Stormwater Management System Report Addendum 2

PROPOSED SITE IMPROVEMENTS

**100 DUCHAINE BOULEVARD
NEW BEDFORD, MASSACHUSETTS**

June 5, 2014
Project No. 1998

Drawing Title: **POST DEVELOPMENT WATERSHED PLAN**

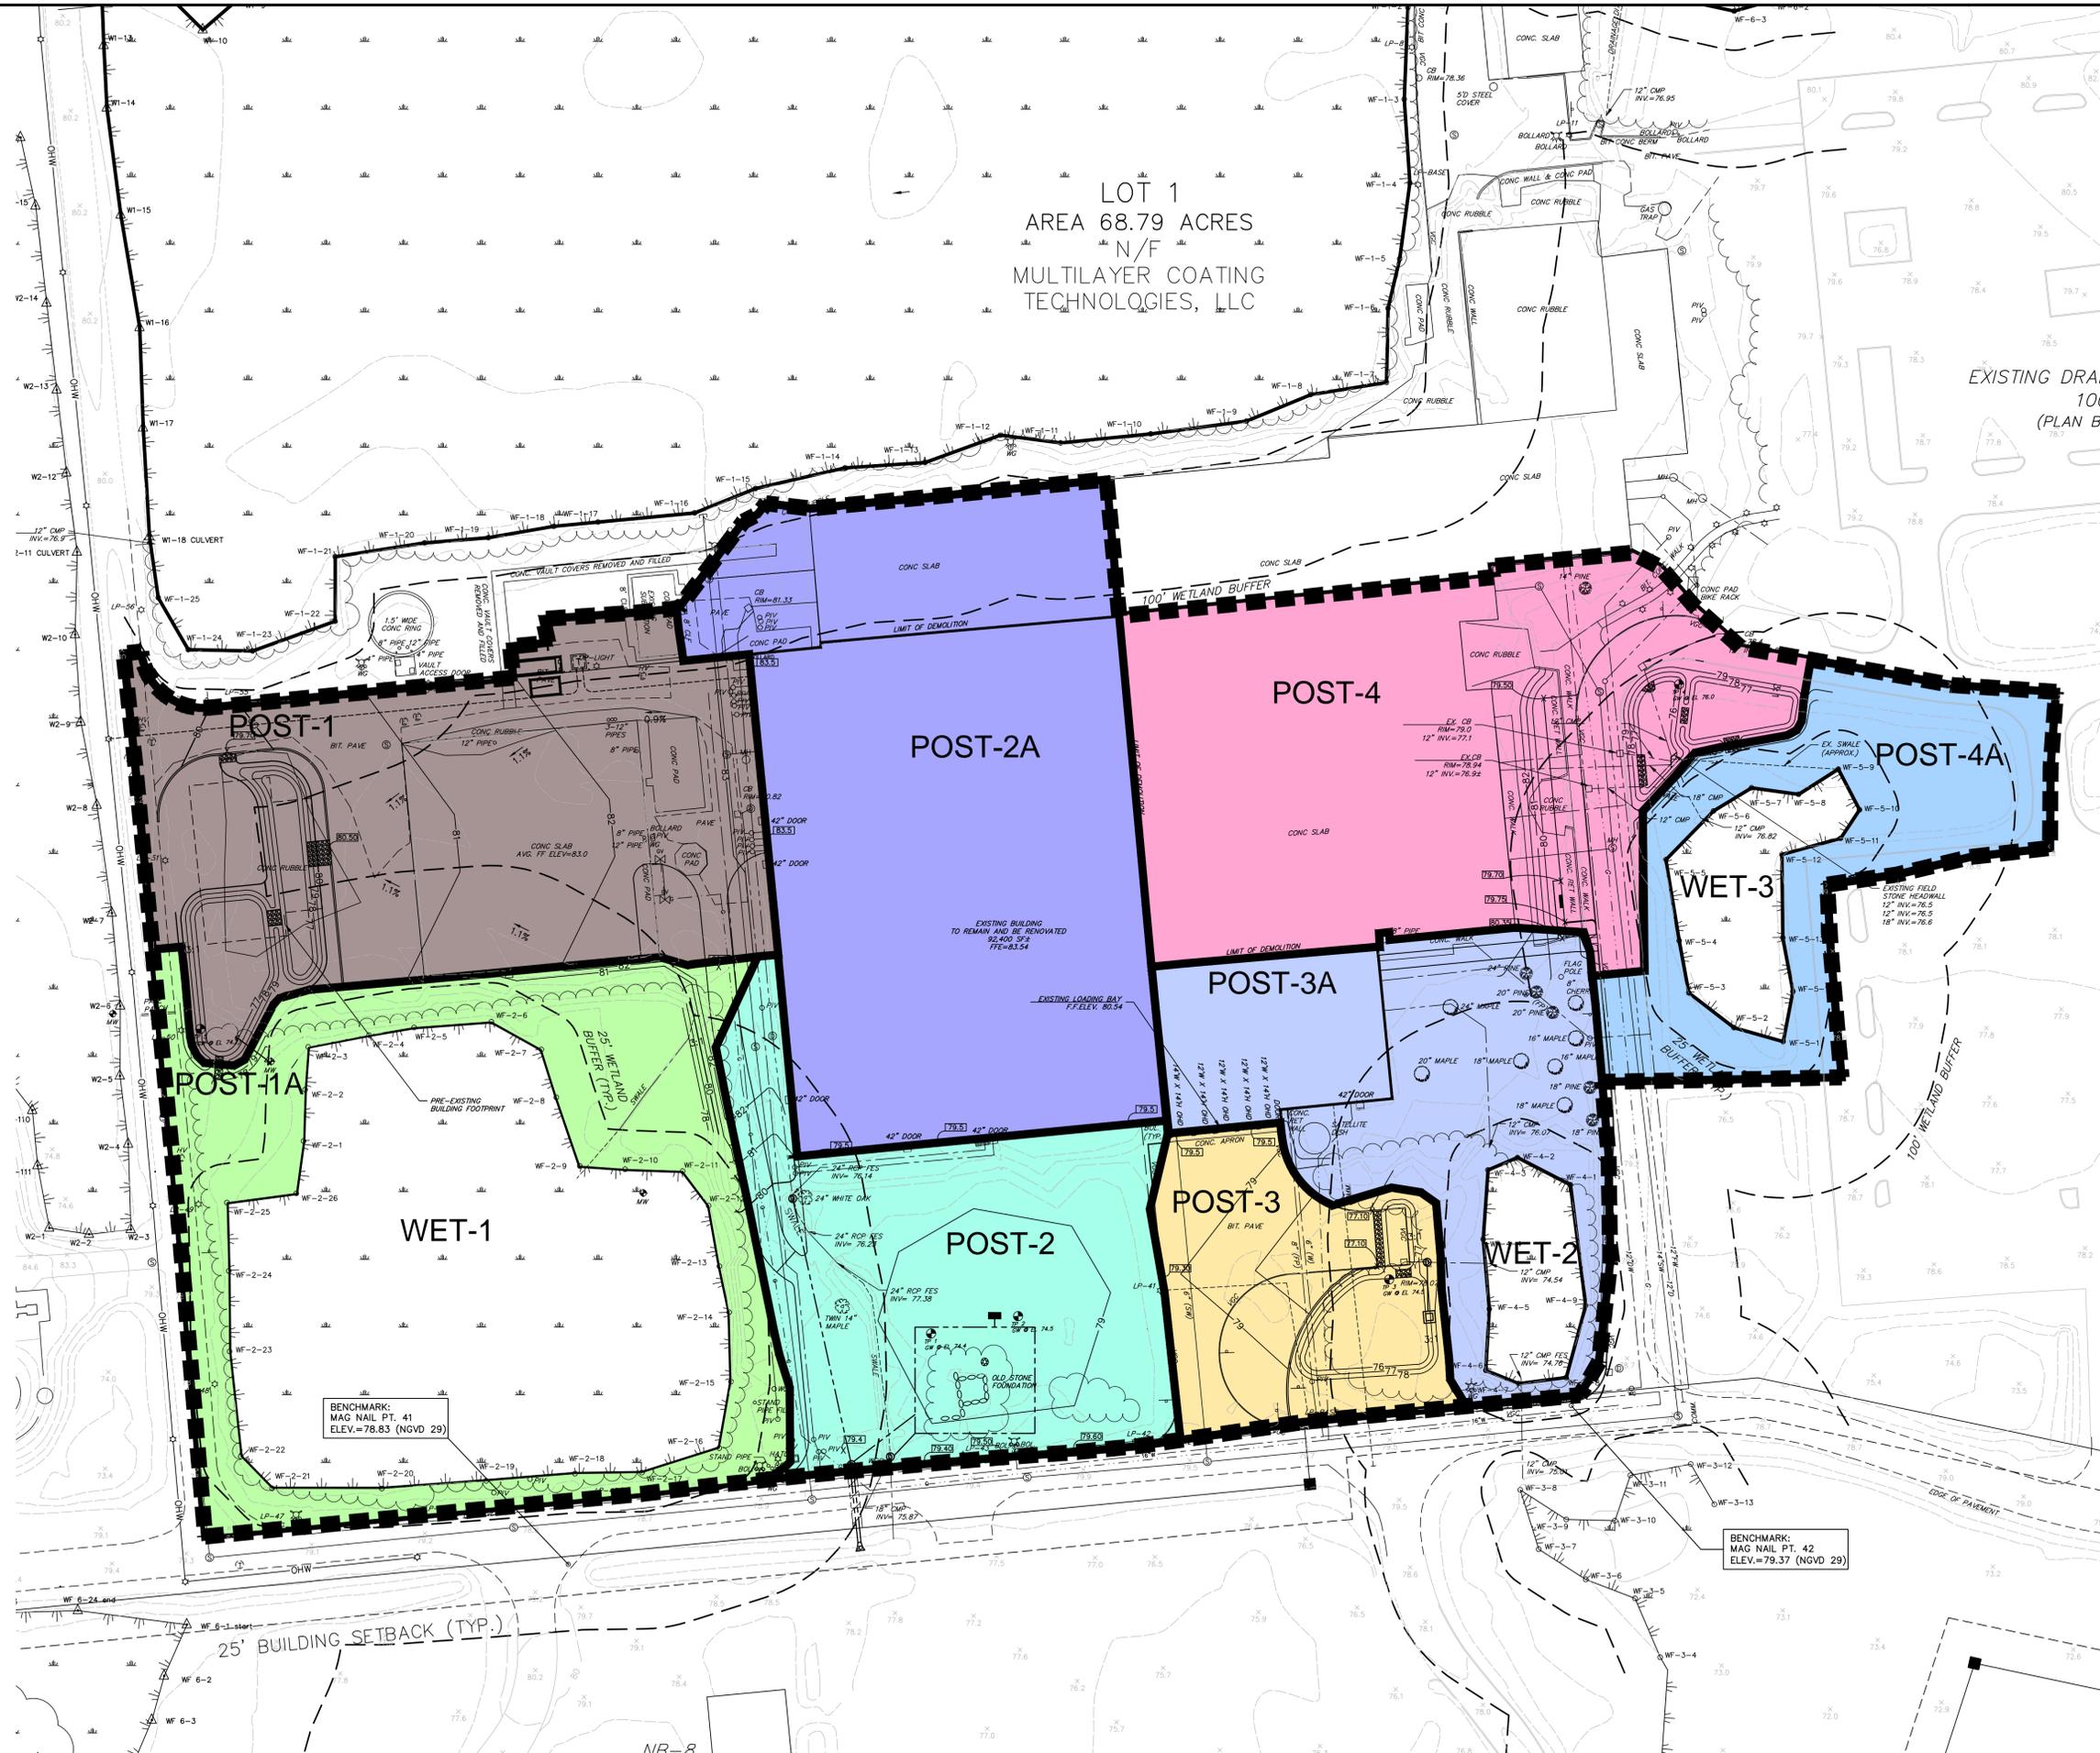
6. The Proposed Conditions HydroCAD Report (revised May 21, 2014) indicates a total modelled area of 459,655 square feet, while the Existing Conditions HydroCAD Report has a total modelled area of 483,284 square feet. The analyzed areas should be consistent.

11. The boundaries for proposed watersheds POST-4 and POST-4A appear to be incorrect based on the proposed grading. It does not appear that the southern portion of the driveway in POST-4 is graded to drain to Bioretention Basin 4, and will therefore not be treated. The Applicant should confirm the intended treatment of the driveway and revised the drainage boundaries as necessary. There are existing catch basins on the driveway that appear to drain to the existing swale that are not shown on the plans. It is unclear whether these catch basins will remain. We recommend that the entire driveway and proposed parking spaces within the limit of work be treated to achieve 80% TSS removal before discharging into the wetland.

6. We have reviewed and revised the Post Development watershed analysis as requested. An updated Post Development watershed analysis has been provided in Addendum 2.

11. We have reviewed and revised the proposed design in this location. We are now proposing to retain the existing driveway and three existing catch basins as they currently stand. We are still proposing to construct Bio-Retention Area 4 and will direct the discharge from the existing catch basins to the sediment forebay. The area of the existing driveway to the south of the proposed parking area will remain unchanged and continue to drain as it does currently. We have also updated the Post Development watershed analysis to account for this plan revision.
